## Service Bulletin

**NUMBER:** M20-158

INSTALLATION OF ALTERNATE STATIC AIR

SOURCE PLACARD (DECAL)

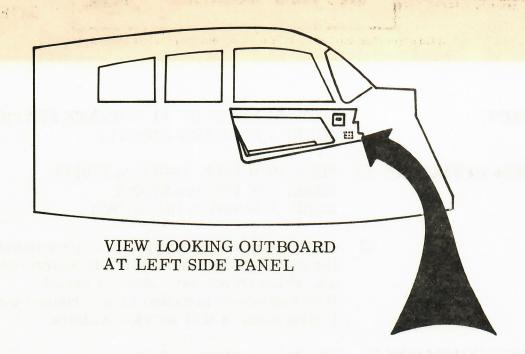
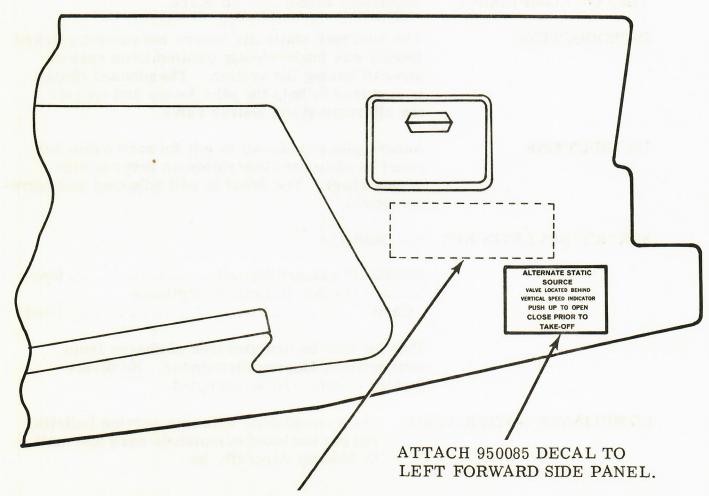
Adhere placard (decal) to left forward cabin side panel as shown in illustration on reverse side of this sheet. The decal is self adhering (pressuresensitive).
